**BEFORE THE BOARD OF ZONING ADJUSTMENT
OF THE DISTRICT OF COLUMBIA**

BZA Application No. 17309
Public Hearing: April 11, 2006
ANC 3D

PRE-HEARING STATEMENT OF OPPONENT
CHAIN BRIDGE ROAD/UNIVERSITY TERRACE PRESERVATION COMMITTEE

Greenhorne & O'Mara, Inc. has been contracted by the Chain Bridge Road / University Terrace Preservation Committee to perform a peer review regarding stormwater management related issues of the BZA Application No. 17309 submitted by Dorchester Associates LLC (the "Applicant"), for a special exception under §2516 of the Zoning Regulations to allow the construction of a theoretical lot subdivision for thirteen (13) single family homes and a modification of the requirement of a twenty-five foot roadway under §2516.6(b) as permitted by §2516.6(d) in the CBUT/R-1-A Zone District on Chain Bridge Road, NW, Square 1425, Lot 827 and Parcels 12/63, 12/293 and 12/294.

Storm Water Management Conceptual Plan

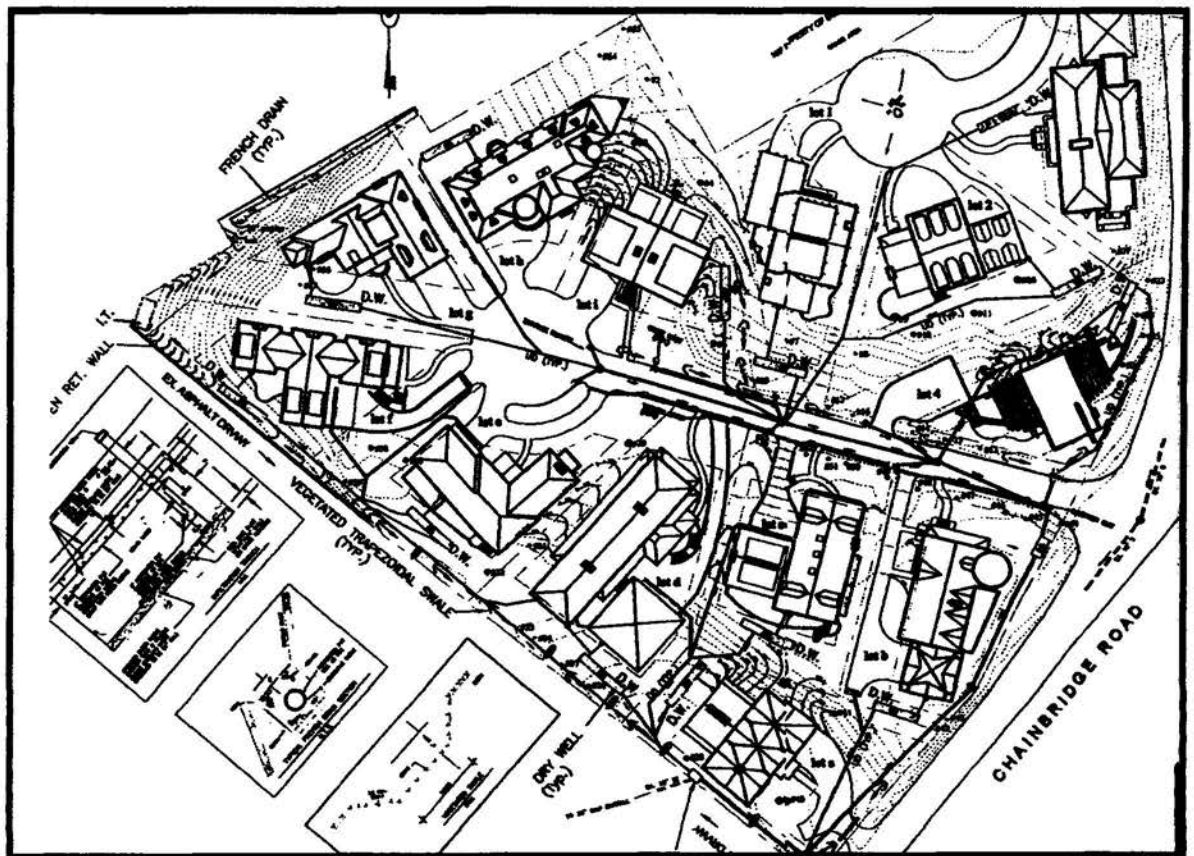
Two documents illustrate what the developer plans to do: the Proposed Grading Plan and the Storm Water Management Conceptual Plan (SWM plan). I am of the opinion that the Proposed Grading Plan is not realistic; and the SWM plan cannot be implemented without killing many of the trees to be preserved.

The SWM plan is below. It shows considerable alteration of the site, none of which appears on the Proposed Grading Plan. Let's take a closer look at this document.

Detail Of The Storm Water Management Conceptual Plan

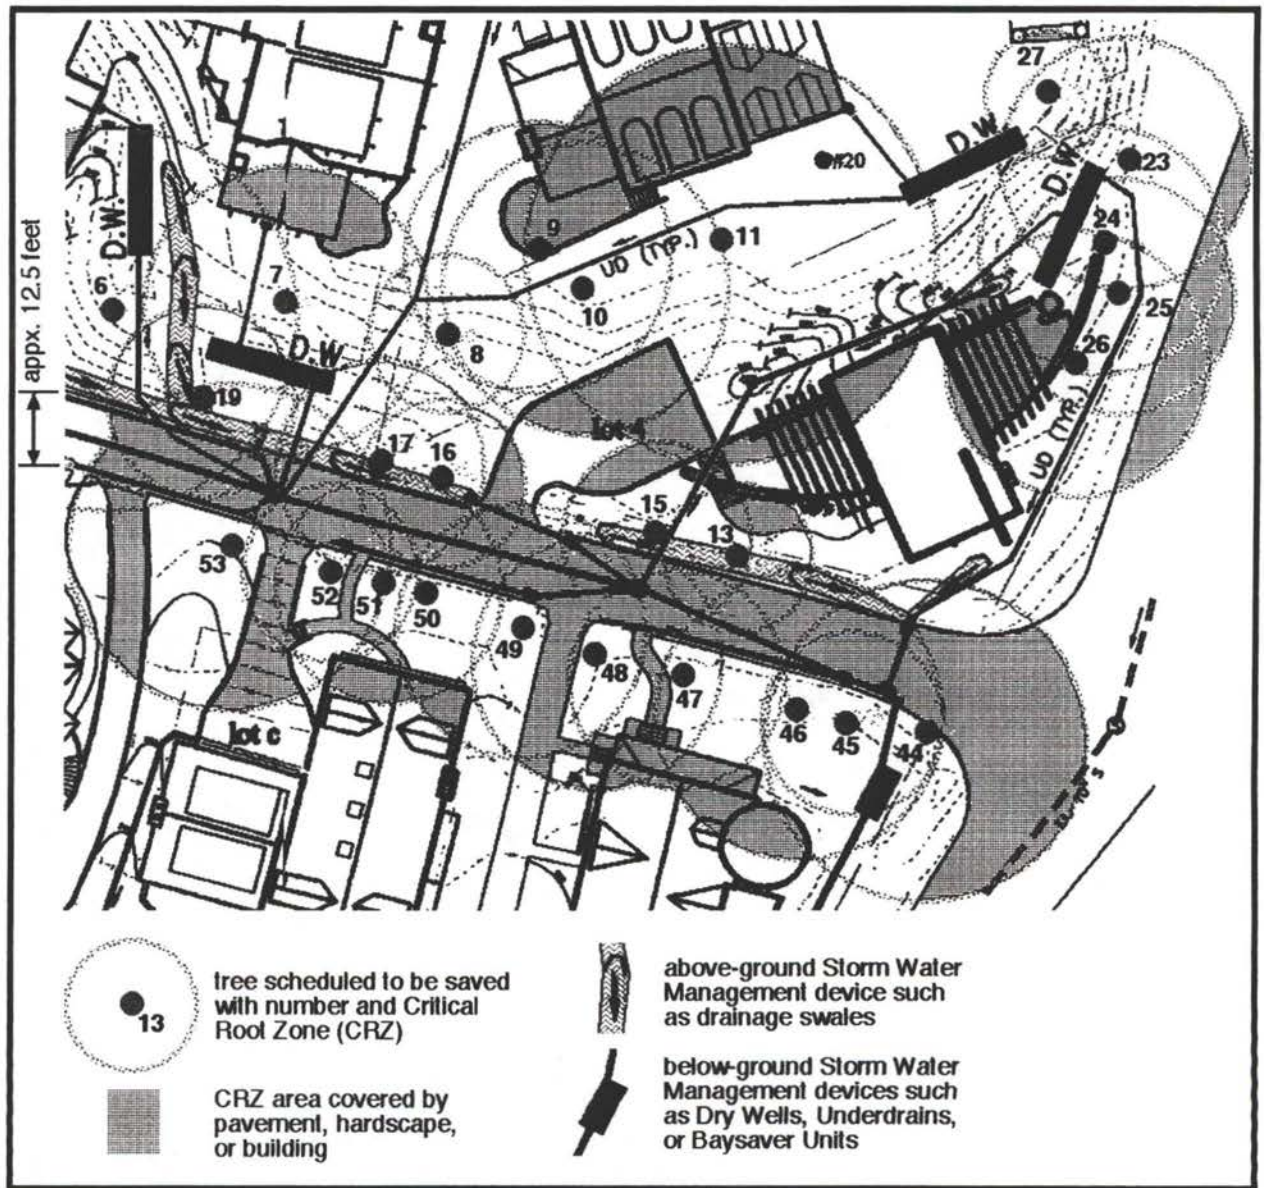
Below is an annotated detail from the SWM conceptual plan, showing the most important trees in the eastern and central part of the site. These include the beech trees along the main entrance roadway (trees #13, 15, 16, 17, 19, 44, 45, 46, 47, 48, 49, 50, 51, 52, 53).

Regarding tree preservation, the plan for Chain Bridge Road Project as presented contradicts itself. It says that the trees will be preserved, while an extensive storm water management system will be installed in the same spaces that the trees occupy. If approved, storm water management will take precedence over trees, and these trees will be taken out.

Site Photograph #1
Chain Bridge Road Project

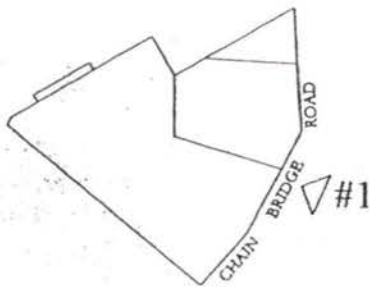
In the *Site Photos* section of the submission, "Site Photograph #1" indicates that there is a hill crest between the entrance from Chain Bridge Road and the rear of the property. (Attached as Exhibit S-1 dated December 1, 2005.) This fact then raises a question as to how the one-lane driveway will function when there are multiple users if drivers at each end can not see each other. Apparently, in recognition of this potential problem, the applicant has proposed the construction of a "layby" starting at the Chain Bridge Road property line and extending for 48.5 feet including tapers. (The full width portion is approximately 25 to 30 feet long.) However, there is no documentation as to how the layby will overcome the lack of direct visual contact between opposing drivers.

Based on the above preliminary analysis, it is my opinion that line of sight along the southerly driveway for the subject property is not adequate to insure that drivers can enter the proposed single lane portion of the driveway without encountering a situation where one or the other will be required to back up to avoid a head-on conflict.

Proposed Grading Plan
Chain Bridge Road Project
Square 1425 Lot 827, Parcels 12/63, 12/293 and 12/294
Washington, DC

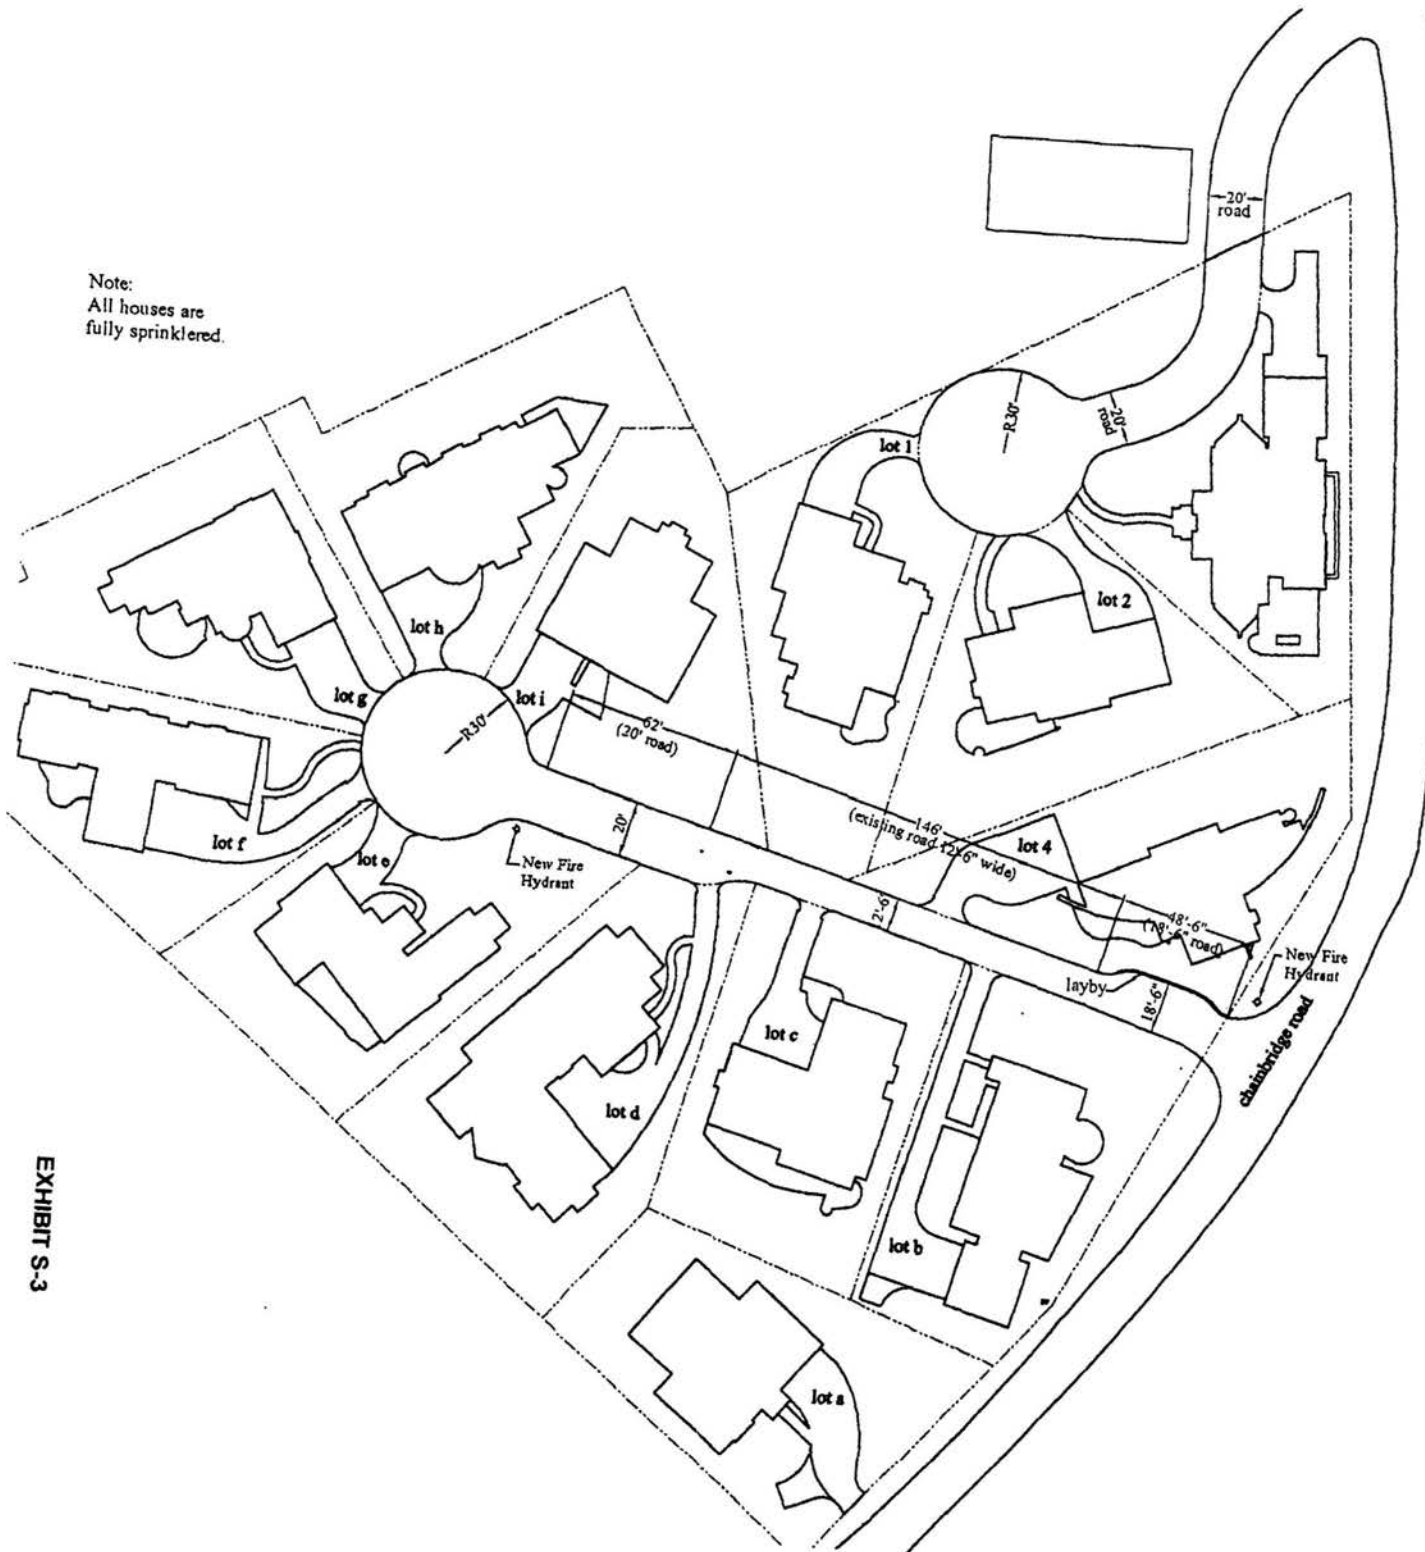
What is immediately striking about this Proposed Grading Plan is how little grading is planned. These thirteen huge houses will be built on this site with barely any change in the topography. The foundations will be dug with exactly the footprint the houses will have, with no overdig. There will be no need to alter the drainage patterns around the houses. All spoil evidently will be hauled away.

To evaluate the sight distance question, two drawings from the applicant's submission were examined. (Attached as Exhibits S-2 and S-3 dated December 1, 2005.) The elevation at the each point where the contours cross the driveway were plotted along the centerline of the driveway to produce Exhibit S-4. The solid black line indicates the profile of the driveway if one was to cut a section in an east-west direction looking north. The west end is at the west edge of the cul-de-sac shown on the "Road Alignment Plan" (Exhibit S-3). The dashed black line with points labeled A and B is the "Line of Sight" between two drivers, one at the west end of the cul-de-sac and the other at the east end of the proposed layby near the entrance from Chain Bridge Road. As demonstrated by the dashed line, which is **below** the profile of the road, neither driver would be aware of the approach of the other.
